Kennecott Eagle Minerals

Re: File Number 08-52-0104-P, Humboldt Mill Joint Permit Application for an Inland Lakes and Streams Permit, Kennecott Eagle Minerals Company

In a letter dated January 7, 2009 a request for clarification/information was received from the Land and Water Management Division (LWMD) titled "Application Correction Request." In fulfillment of your request, please find attached, answers to your questions, additional engineering detail and supporting documentation.

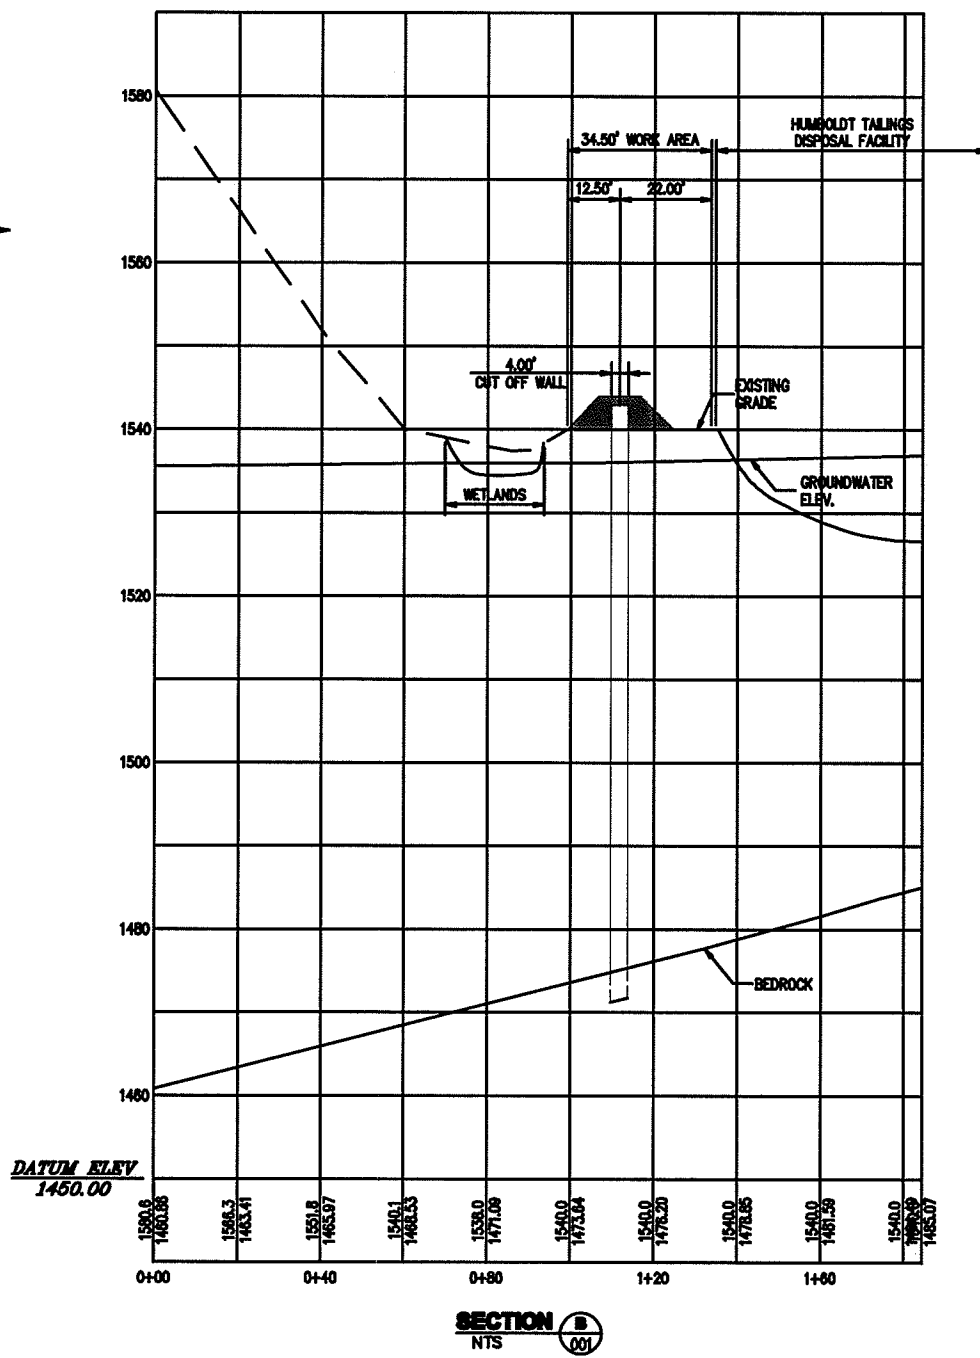
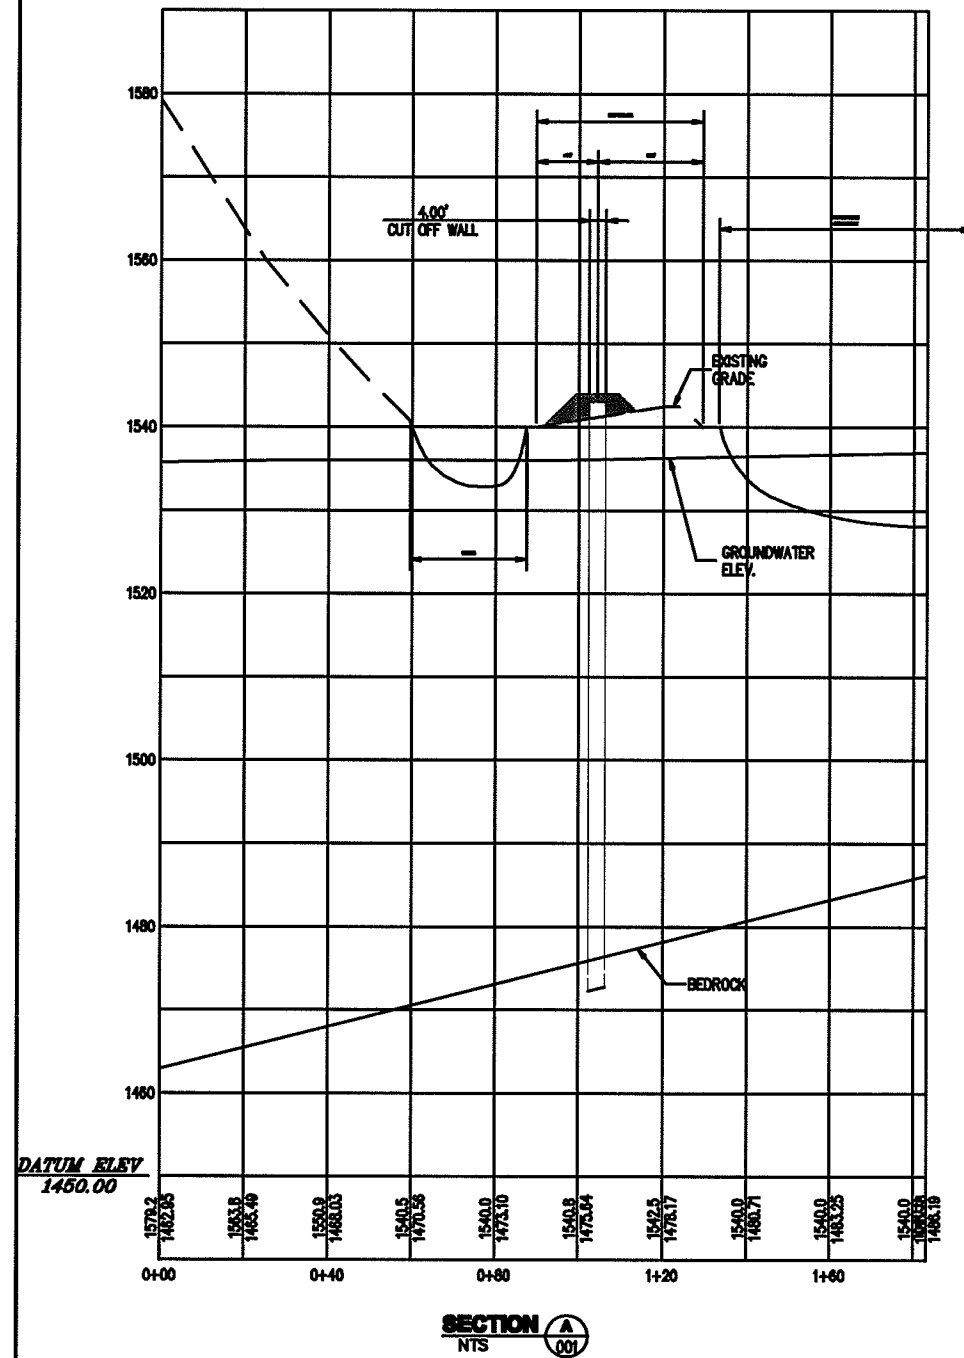
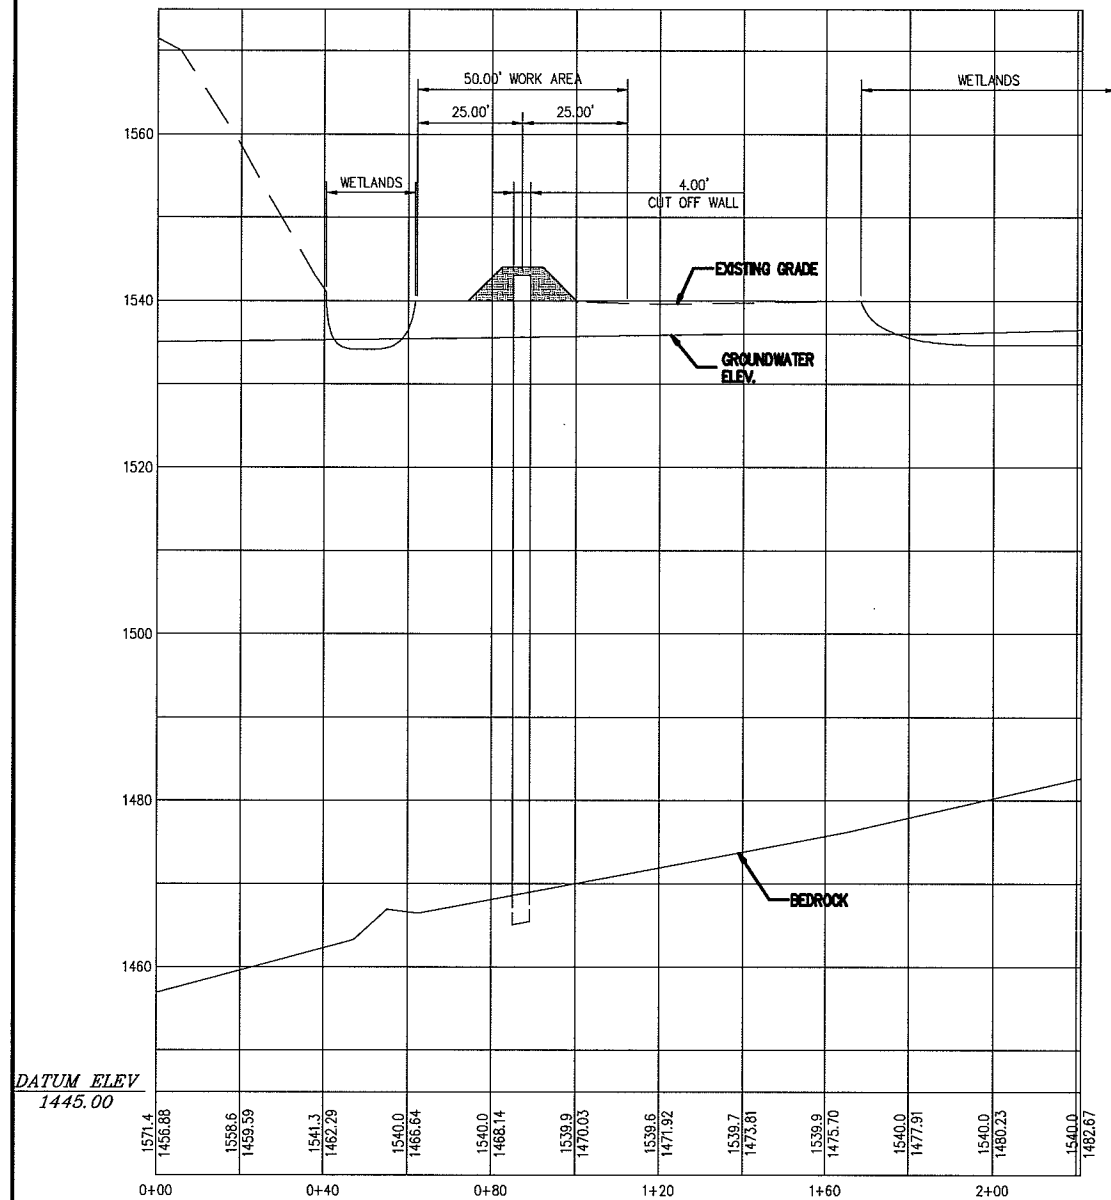
6. Provide black and white cross sections of the cutoff wall / slurry wall and berm showing boundaries of adjacent wetland, width of work area, and structure dimensions. Include height, base and top widths of the berm. Indicate length of the proposed berm. Enclosed is a site plan for reference.

Figure 2-5a shows the cutoff wall and berm details in detail, profile and plan view, Figure 2-5b provides information for Sections A-A' and B-B' and Figure 2-5c contains Sections C-C', D-D' and E-E'. Copies of all three new figures are contained in Attachment D.

KENNECOTT EAGLE MINERALS
JOB NO. M3-PN09005
FIGURE 2-6a HUMBOLDT TAILINGS DISPOSAL FACILITY CIVIL WWTP OUTLET
DWG NO. 600-EN-002
REV NO. P1 06 FEB 09

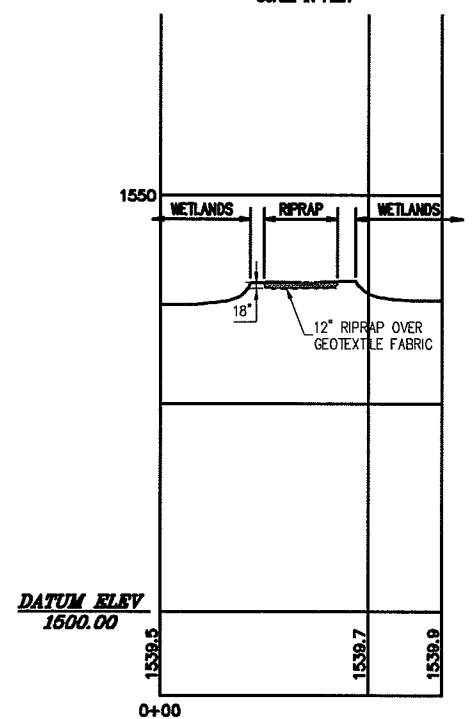
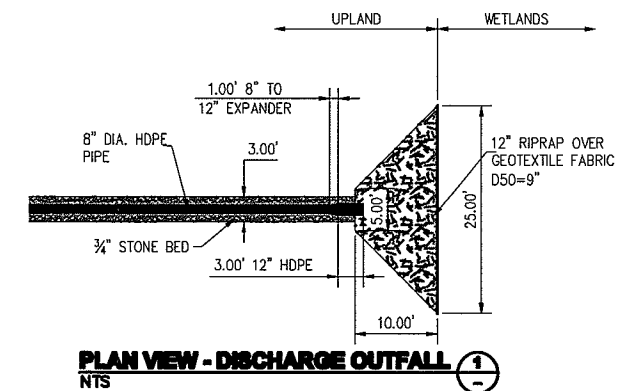
8. Provide a site specific profile and cross section of the outlet discharge into the wetland showing

- a. Wetland edge/boundaries**
- b. Location, dimensions and discharge elevation of the proposed structure**
- c. Location and dimensions of proposed excavation/dredge and/or fill areas**
- d. Location and dimensions of excavation/dredge spoil areas**
- e. Existing and proposed grades**
- f. And cross section scale**

KEMC Response: *Updated drawings of Figure 2-6 have been created consistent with the sample drawing provided in your January 7, 2009 letter. Please replace the original Figure 2-6 with Figure 2-6a and Figure 2-6b showing the stationary water intake structure and the outlet discharge into the wetland. Figures 2-6a and 2-6b are contained within Attachment E.*

Figure 2-6a shows the wetland boundary/edge, location, dimensions and discharge elevation of the outlet structure, grades and a cross section scale. Items 8c and 8d are not applicable since dredging, excavation, spoils or fill are not currently planned.

Figure 2-6a also provides information for Section G-G' and F-F'.

KENNECOTT EAGLE MINERALS
FIGURE 2-86 HUMBOLDT TAILINGS DISPOSAL FACILITY PIPING WTP INTAKE PUMP HOUSE
JOB NO. M3-PN09005
DWG NO. 000-EN-005
REV NO. P1
06 FEB 09

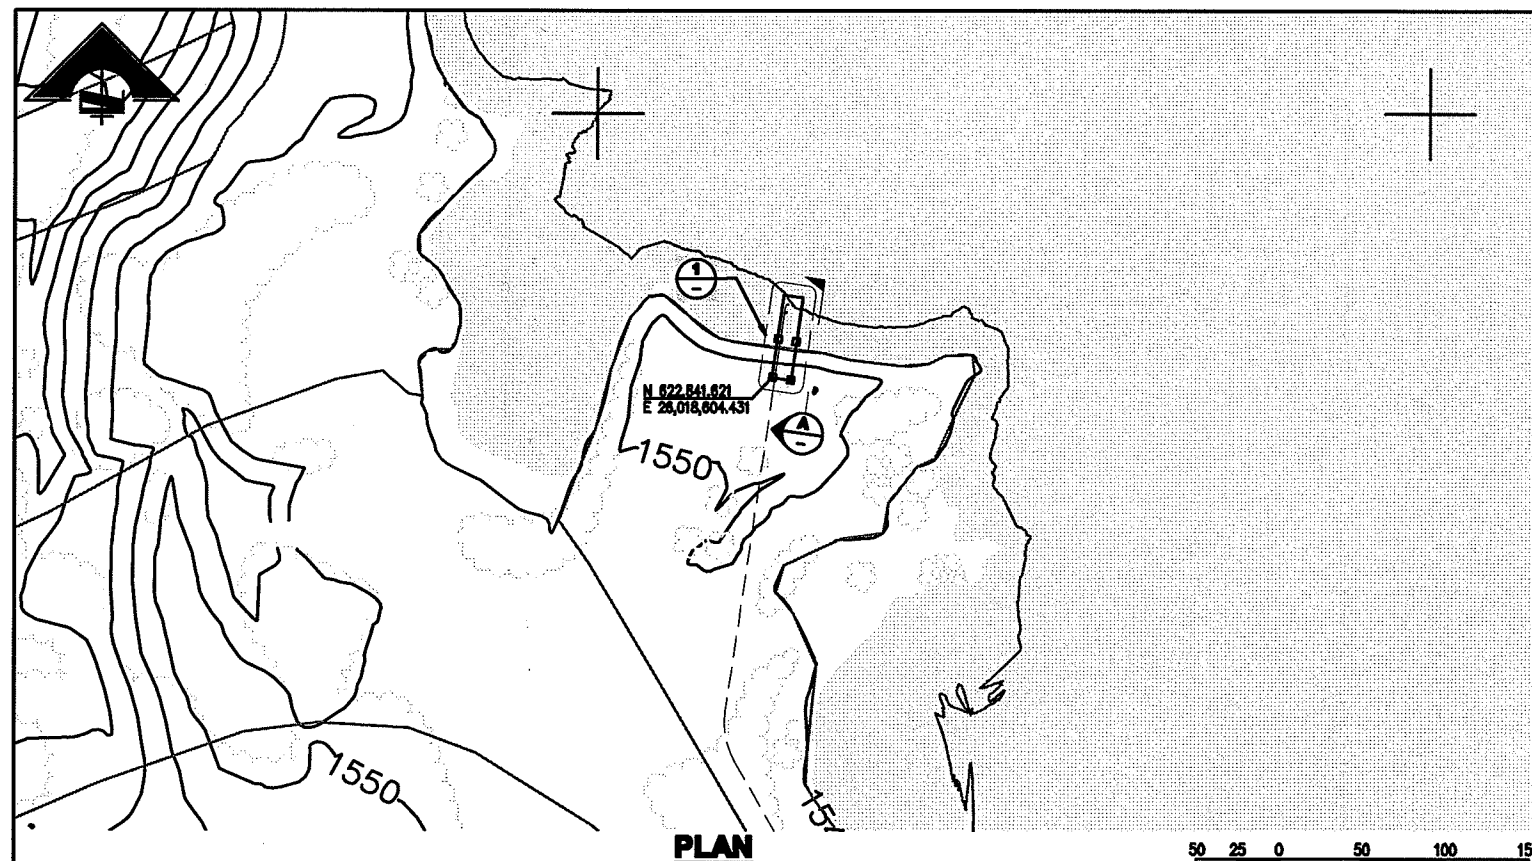
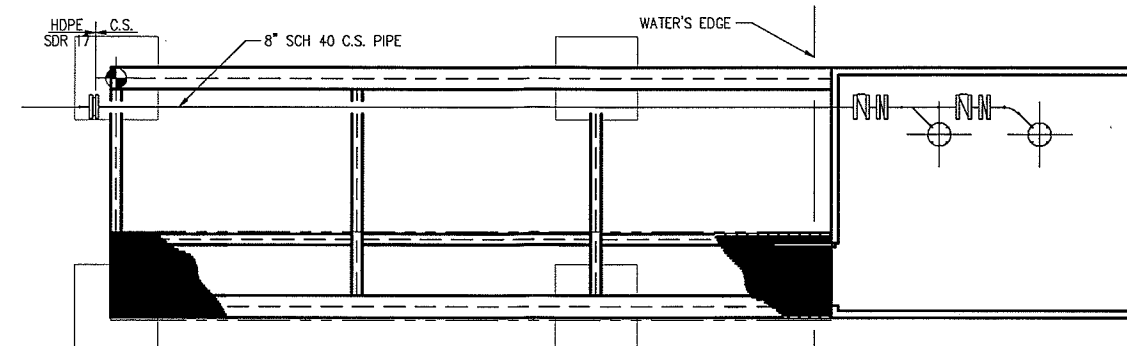
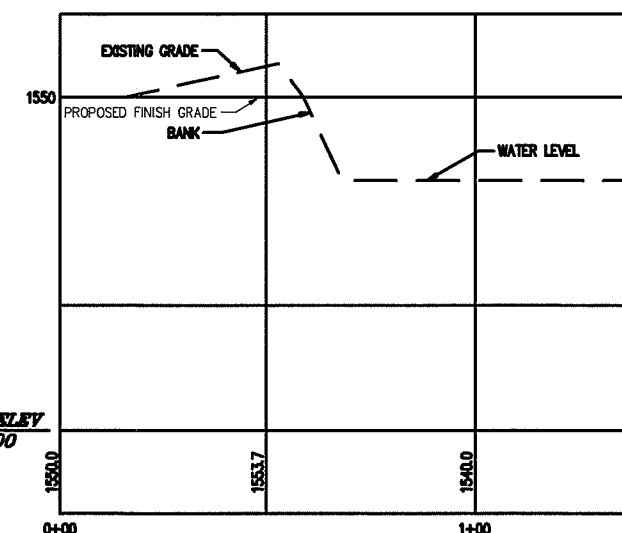
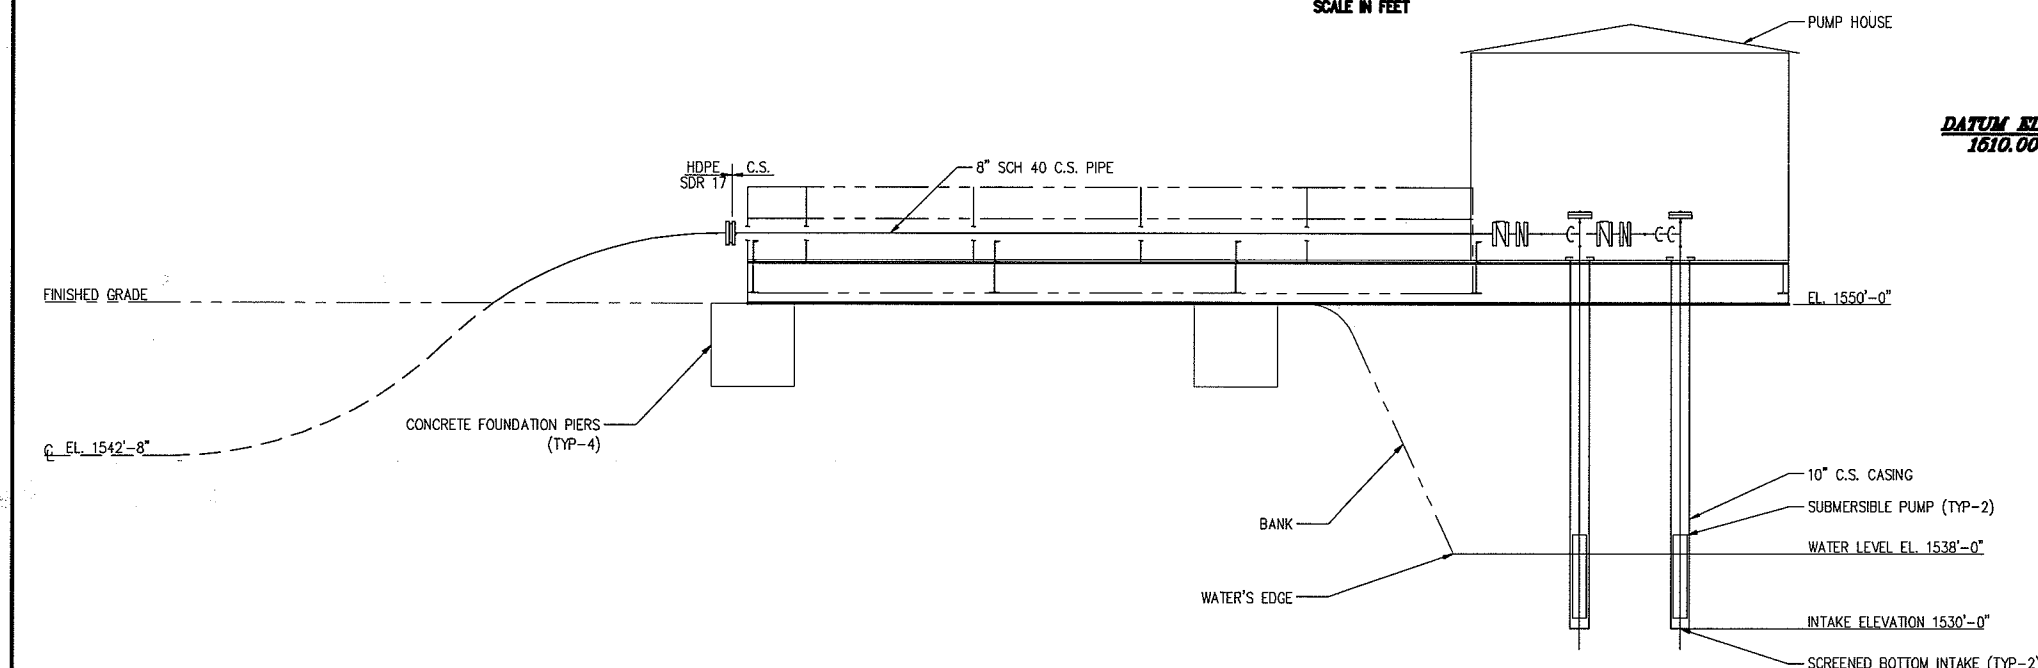
7. Provide a site specific profile and cross section of the stationary water intake structure showing

- a. The waters edge**
- b. Location, elevation and dimensions of the proposed structure**
- c. Location and dimensions of proposed excavation/dredge and/or fill areas**
- d. Location and dimensions of excavation/dredge spoil areas**
- e. Existing and proposed grades**
- f. And cross section scale**

KEMC Response: *Updated drawings of Figure 2-6 have been created consistent with the sample drawing provided in your January 7, 2009 letter. Please replace the original Figure 2-6 with Figure 2-6a and Figure 2-6b showing the stationary water intake*

structure and the outlet discharge into the wetland. Figures 2-6a and 2-6b are contained within Attachment E.

Figure 2-6b shows the waters edge of the HTDF, location, elevation and dimensions of the intake structure, grades and a cross section scale. Items 7c and 7d are not applicable since dredging, excavation, spoils or fill are not currently planned.
